#	Date	Issue / Description
01	05/02/16	1ST PLANNING SUBMITTAL
02	09/15/16	2ND PLANNING SUBMITTAL

# METRO CENTER

**ALAMEDA PARKWAY & SABLE BLVD.  
AURORA, CO 80012**

**WOODBURY CORPORATION**

TITLE:  
ENLARGED LANDSCAPE PLAN  
PLANNING AREA 3

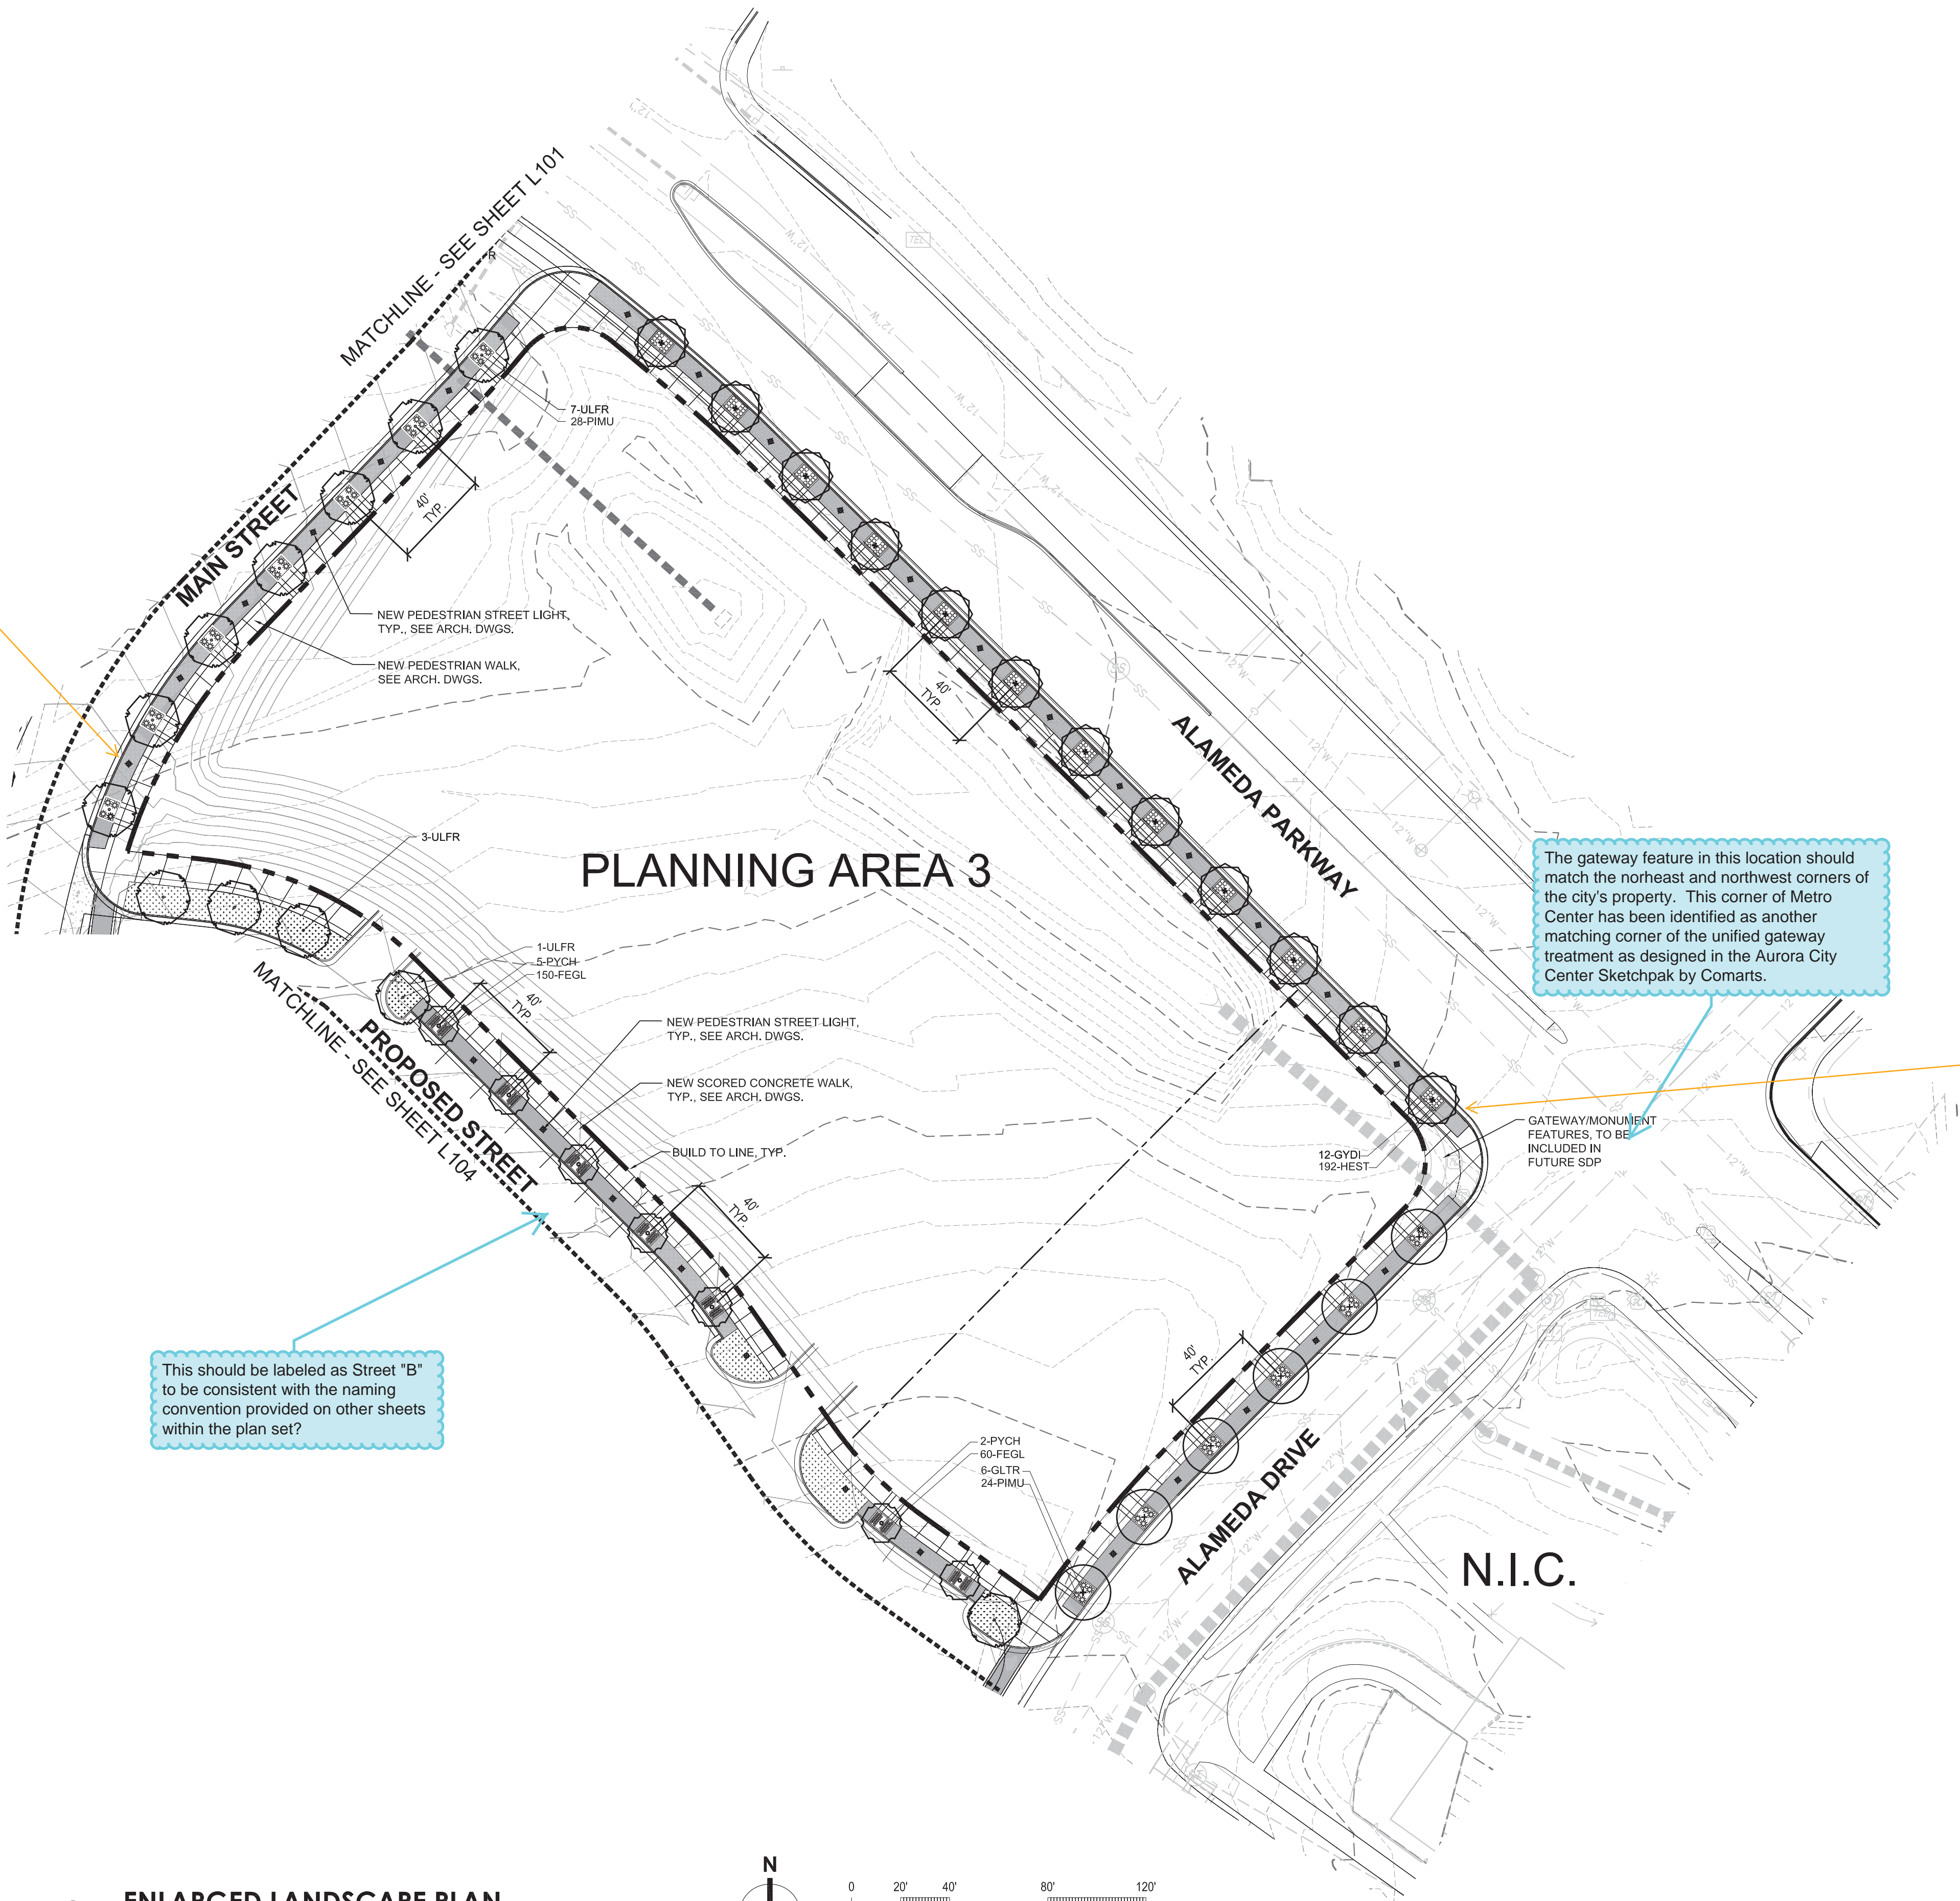
These will need to be large trees on install to meet sight distance requirements (must be clear 3' to 7' vertically). Show sight lines per COA STD Detail TE 13.1

The gateway feature in this location should match the northeast and northwest corners of the city's property. This corner of Metro Center has been identified as another matching corner of the unified gateway treatment as designed in the Aurora City Center Sketchpak by Comarts.

These will need to be large trees on install to meet sight distance requirements (must be clear 3' to 7' vertically). Show sight lines per COA STD Detail TE 13.1

This should be labeled as Street "B" to be consistent with the naming convention provided on other sheets within the plan set?

TITLE:  
ENLARGED LANDSCAPE PLAN  
PLANNING AREA 4

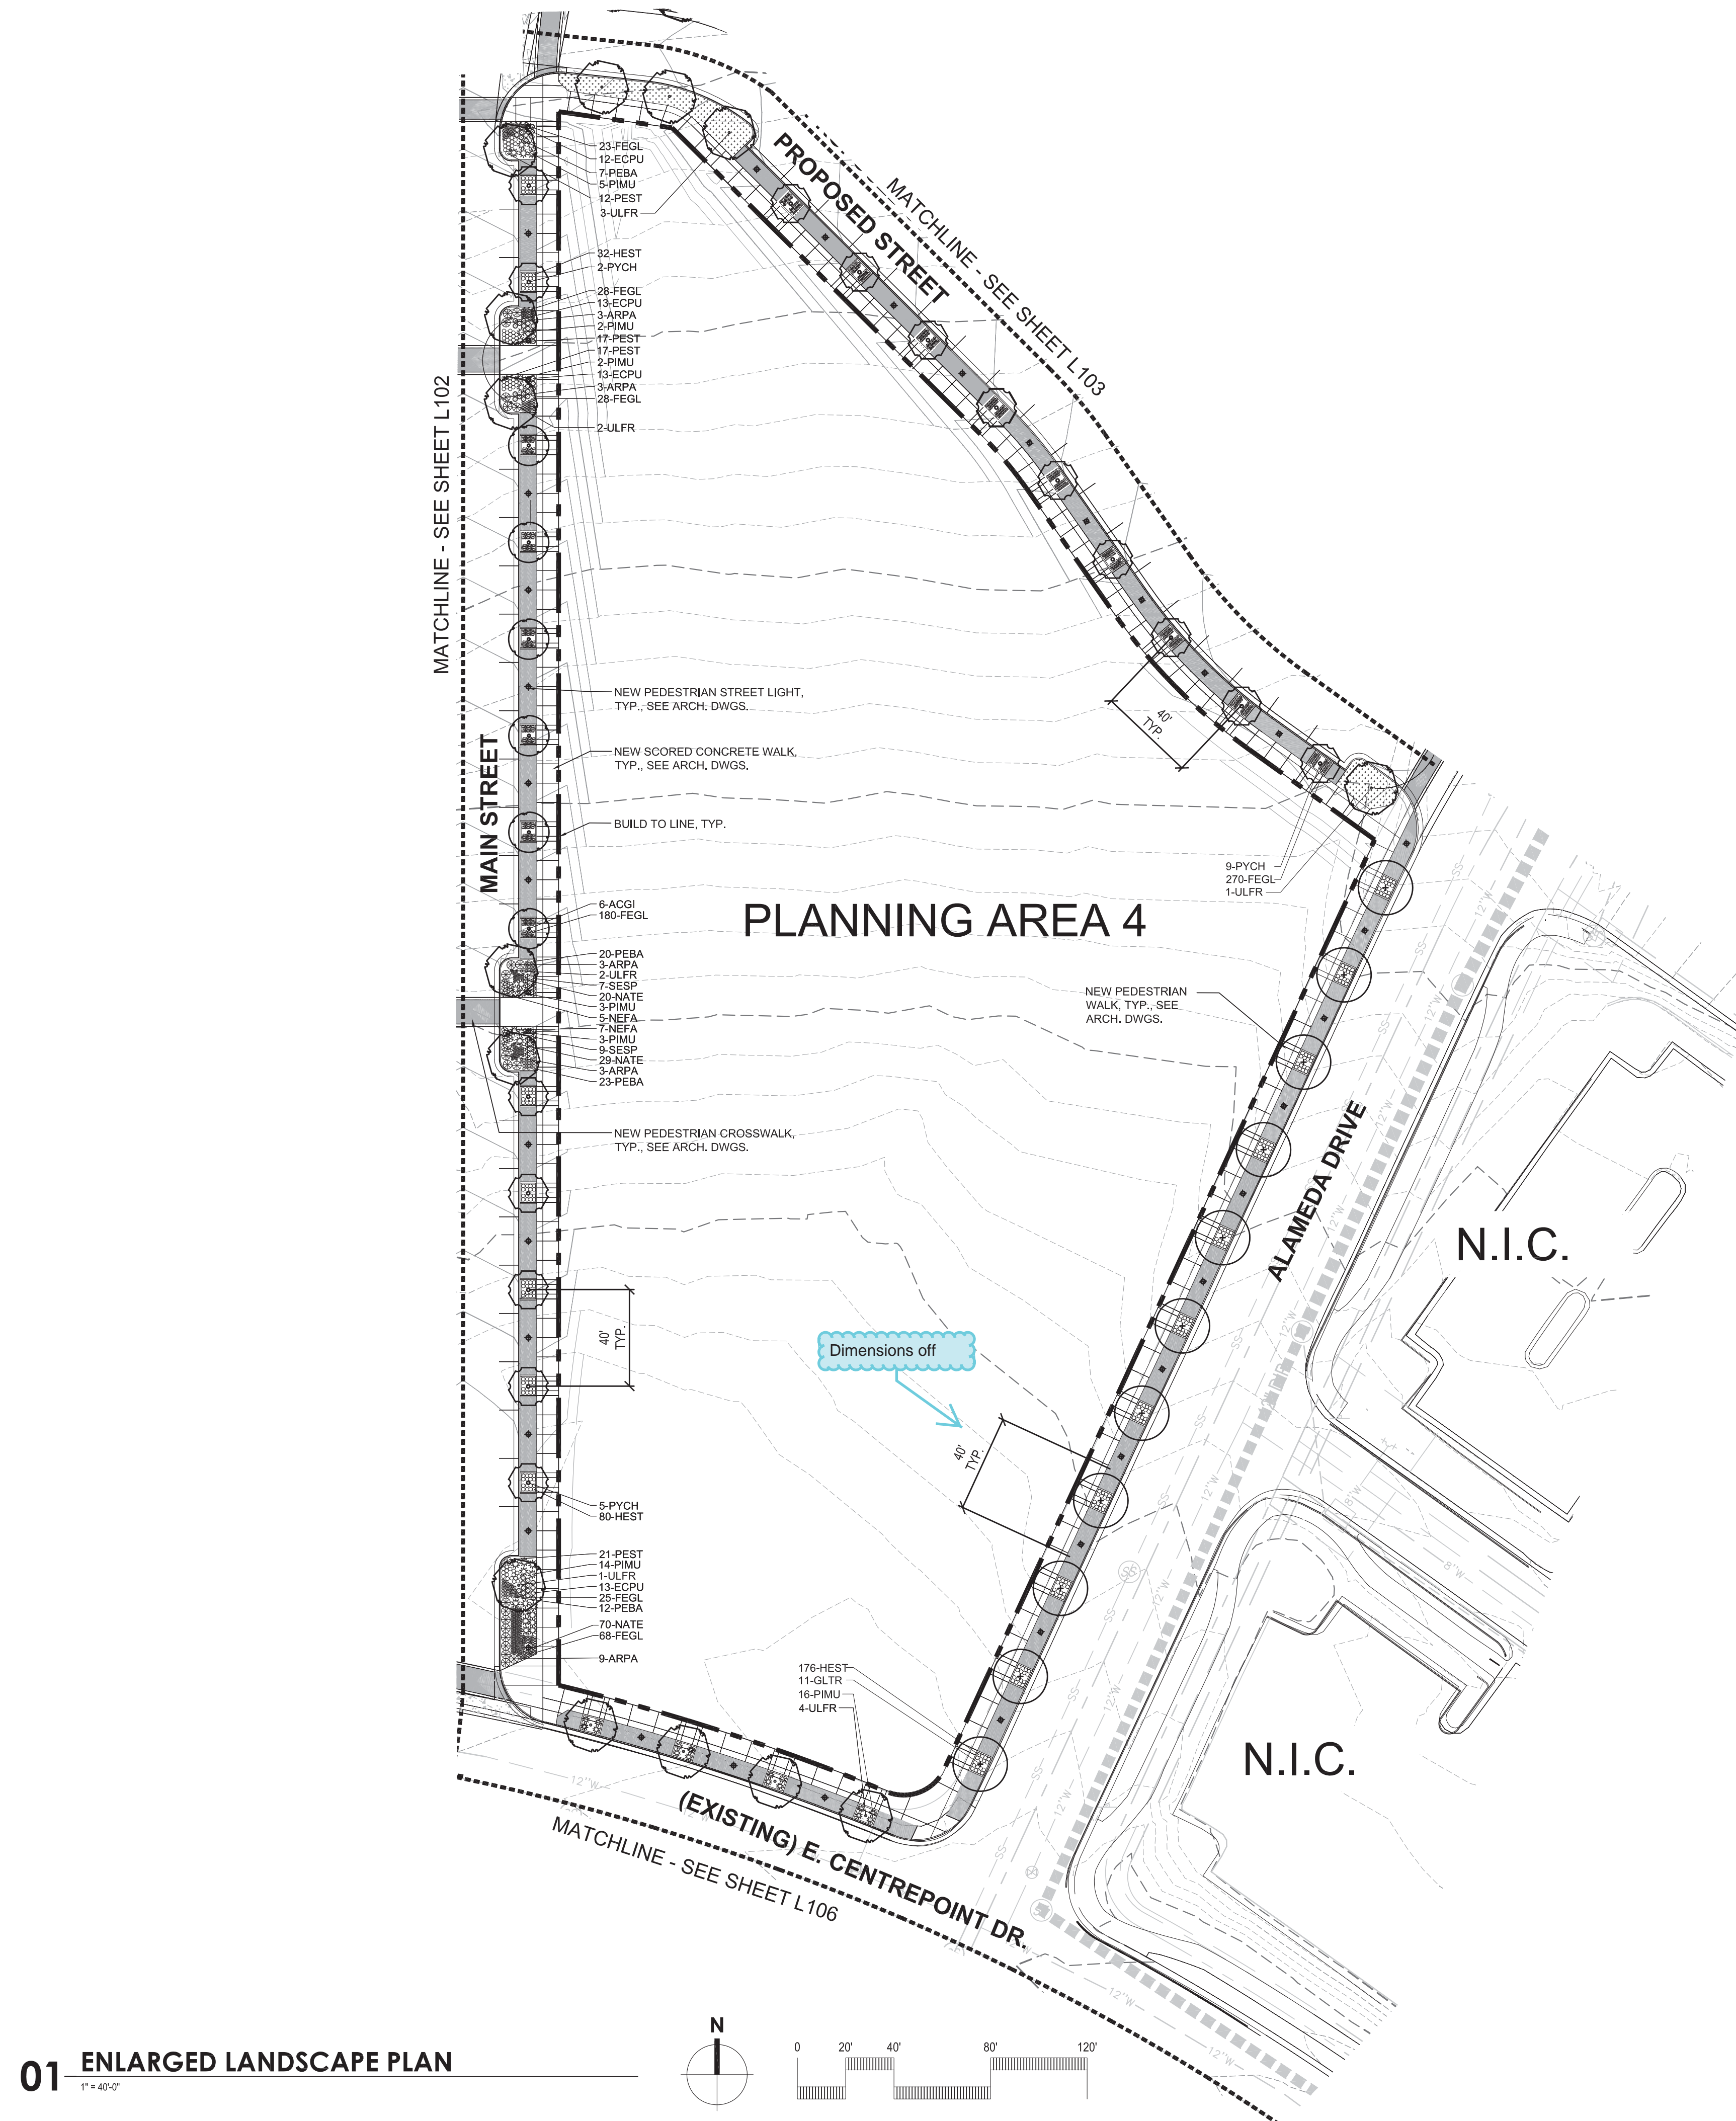
Provide a conceptual location for the proposed connection to the Kasier facility and label as conceptual, final location to be determined. This needs to be shown as a connection to be included in future site plan submittals.

TITLE:  
ENLARGED LANDSCAPE PLAN  
PLANNING AREAS 7 & 8  
**L107**

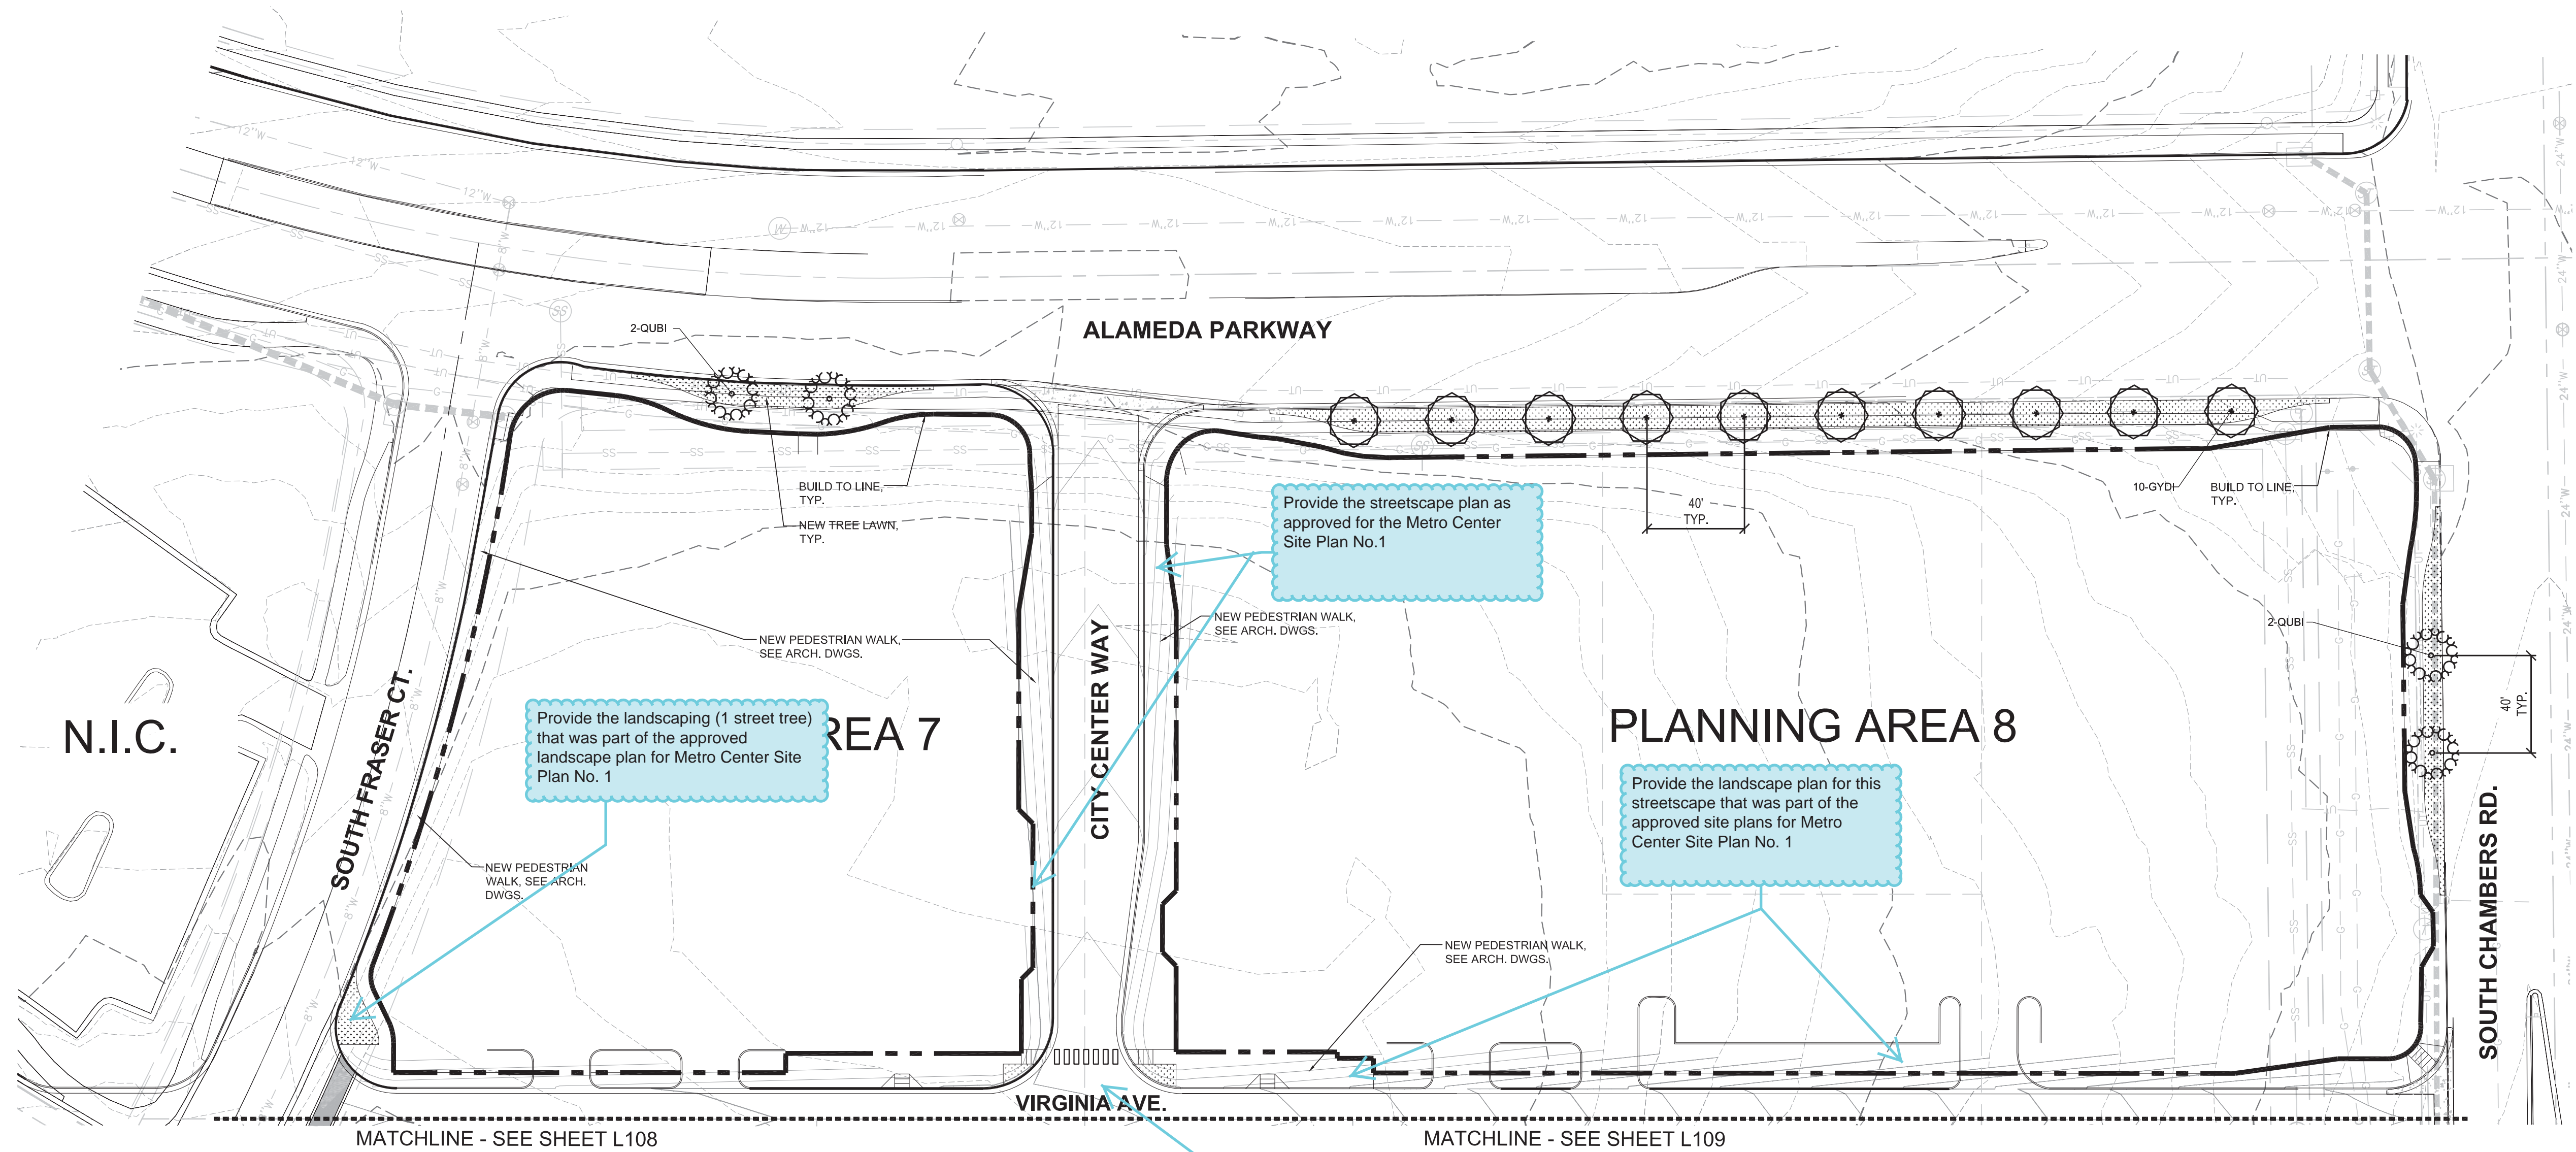
The intersection  
design/pavement  
theme should be  
included as part of  
the approved  
Metro Center Site  
Plan No.1

CAD BACKGROUNDS AS SHOWN CORRESPOND TO  
METRO CENTER SITE PLAN NO. 1.
